Alcohol and Marijuana Control Office

November 6, 2019

Re: Application for addition of Onsite Consumption Endorsement to Retail Marijuana Store License #10590

- **MJ-14 Licensed Premises Diagram Change**
  - Some of the room labels and many of the dimensions are difficult to see. Can you provide a copy of this diagram with clearer labeling?

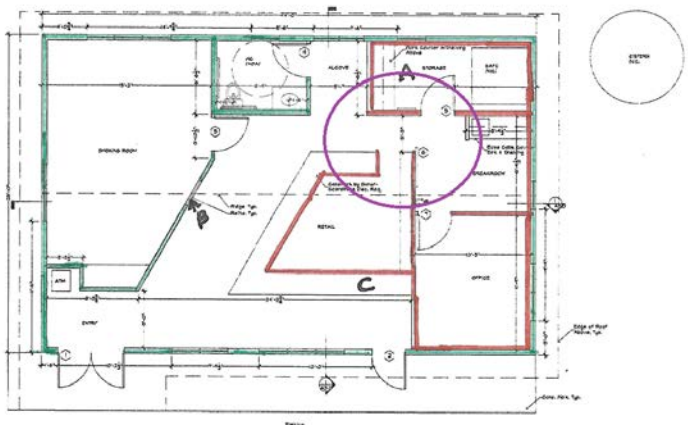
- Please label the following information:
    - The area where surveillance equipment is stored
    - The Point of Sale area
  - Is the sales counter designated as a restricted access area? It appears that the area behind the counter is restricted access, but not the counter itself. Under 3 AAC 306.325(c), an area where marijuana is stocked or dispensed for sale is a restricted access area.

- It isn't clear where the Restricted Access Areas begin and end between the sales area and break room. Can you show on your diagram where the Restricted Access Area ends within the area circled in purple on the next page?
